UNITED STATES PATENT AND TRADEMARK OFFICE

APPLICATION NO.	FILING DATE	FIRST NAMED INVENTOR	ATTORNEY DOCKET NO.	CONFIRMATION NO.
10/637,191	08/08/2003	Jurgen Muller	P2001,0082	3966
24131	7590	08/18/2005	EXAMINER	
LERNER AND GREENBERG, PA P O BOX 2480 HOLLYWOOD, FL 33022-2480			NGUYEN, PHILLIP	
			ART UNIT	PAPER NUMBER
			2828

Office Action Summary	Application No.	Applicant(s)	
	10/637,191	MULLER, JURGEN	
	Examiner	Art Unit	
	Phillip Nguyen	2828

DETAILED ACTION***Response to Arguments***

Fig. 5

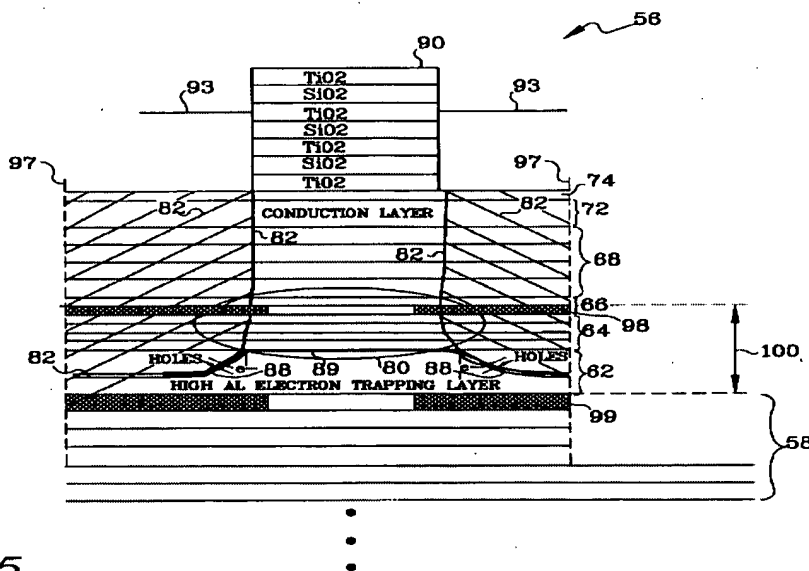
With respect to claim 1, Johnson discloses in Fig. 5 a semiconductor laser comprising a vertical resonator formed by reflectors (90 and 58); a photon-emitting active layer (80) disposed between said reflectors; at least one current diaphragm (98 and 99) for laterally circumscribing a current flowing through said photon-emitting active layer; and mode-selective regions (82) extending from a vertical direction within said vertical resonator and laterally delimit said vertical resonator.

With respect to claim 2, Johnson further discloses a mesa and one of said reflectors (90) is formed in said mesa.

With respect to claim 10, Johnson discloses said vertical resonator has an edge area (97) and said mode-selective regions extend in said edge area and a surrounding region of said edge area of said vertical resonator.

With respect to claim 11, Johnson discloses said current diaphragm is at least two current diaphragms (98 and 99).

With respect to claim 12, Johnson discloses the semiconductor laser has a multilayer structure (from layers 58-90) and said mode-selective regions are formed within said multilayer structure.

With respect to claims 3 and 5-6, Johnson discloses the claimed invention and also the mode-selective region defining an inner opening being larger than said current aperture (see Fig. 5) except for explicitly teaching the diameters of the mesa and aperture. Choquette discloses in Fig. 1 the claimed invention along with a mesa has a diameter of larger than 10 and a current diaphragm 20 defines a current aperture having a given diameter of larger than 3 μm (col. 9, lines 59-65) except for the mode-selective region being within said resonator. For the improvement of the laser device, it would have been obvious to the one having ordinary skill in the art at the time the invention was made to provide diameters of the mesa and current aperture larger than 10 μm and larger than 3 μm , respectively, because it is well known in the art to design such diameters.

With respect to claim 7, Johnson discloses in Fig. 5 the mode selective regions defining an inner opening being larger than said current aperture.
